ADDRESSEES	: ABC Customer Care and Parts Source
COACH/BUS MODEL	: T900 Series
BULLETIN TYPE	: Parts Information
SECTION/CHAPTER	: Body and accessories
DATE	: October 28, 2008
SUBJECT	: Remanufactured body parts
TERMS & CONDITIONS	: No claims will be accepted with reference to this Bulletin.

This Bulletin informs of T900 Series lamps and body parts that are no longer available as service replacements.

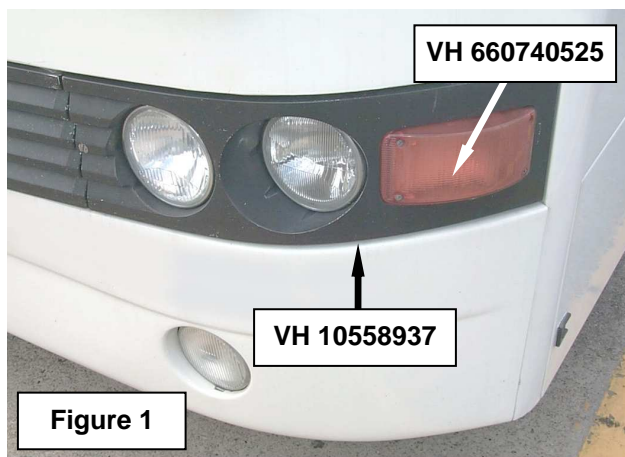
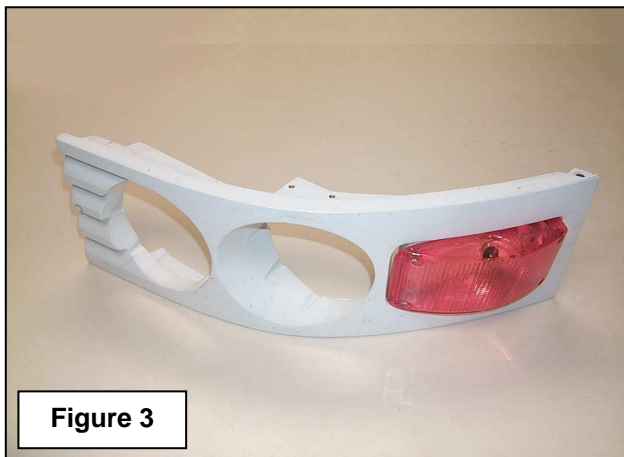
1. Front turn signal lamps VH 660740530 (RH) and VH 660740525 (LH), have been phased out by Hella, who manufacture these items.
2. Production of head lamp and turn signal lamp bezels VH 10558936 (RH) and VH 10558937 (LF), and grille VH 10558935 has also ceased (Figures 1 and 2).

3. To address the issue, Van Hool offer round Arcol turn signal lamp VH 10985539 as service replacement for the old oblong Hella lamps.
To accept the new turn signal lamps, new retro-look bezels have been designed and manufactured.
While not required, a remanufactured grille has been made available to update and complete the appearance of the installation.
Refer to the parts and products section below for more details.

VH reference	Description	Qty.
VH 10985539	Lamp, turn signal, nondirectional, white lens	1
VH 10737576	Bulb, orange, to fit VH 10985539	1
VH 11070583	Bezel, headlamp and turn signal, LH, black, includes lamp frame	1
VH 11070582	Bezel, headlamp and turn signal, RH, black, includes lamp frame	1
VH 11070581	Grille assy, black, badge VH 660160605 not included	1

- Bezels and grille are of the angled louver design as found on later coaches. These parts also fit earlier coaches with flat louver design bezels and grille.
- Old and new parts are not interchangeable.
- Parts may be purchased from your nearest ABC Customer Care & Parts Source service center.
- Parts and products disposition: discard according to applicable environmental regulations.
